## **PLAN REVIEW SHEET**

2014-023

Edgeline Residential, LLC

**Waiting Pad Detail**

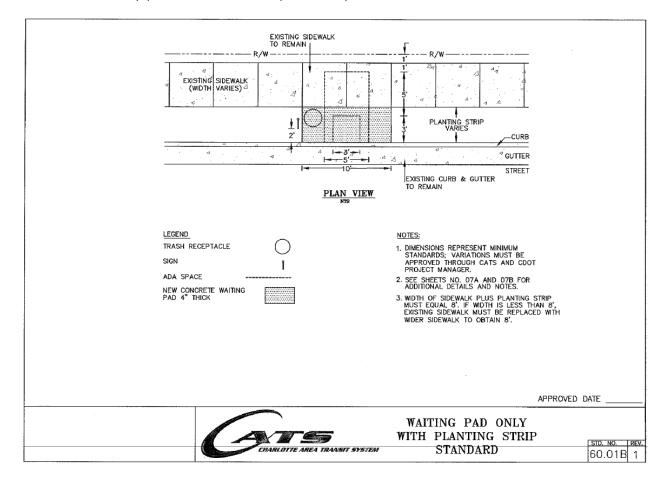
The Petitioner is requested to provide and construct a concrete waiting pad for the existing bus stop along North Davidson Street. The location of the pad may move farther south to avoid a stopped bus blocking the intersection of 16<sup>th</sup> Street. The pad should be spaced midway between existing street trees within the existing planting strip and aligned with existing sidewalk concrete panels. Below is an image of the standard detail (60.01B) for the requested bus stop pad.

The site plan may either show the conceptual location of the improved bus stop on North Davidson Street, or alternatively, include a development note to locate the bus stop pad during the development review and permitting process.
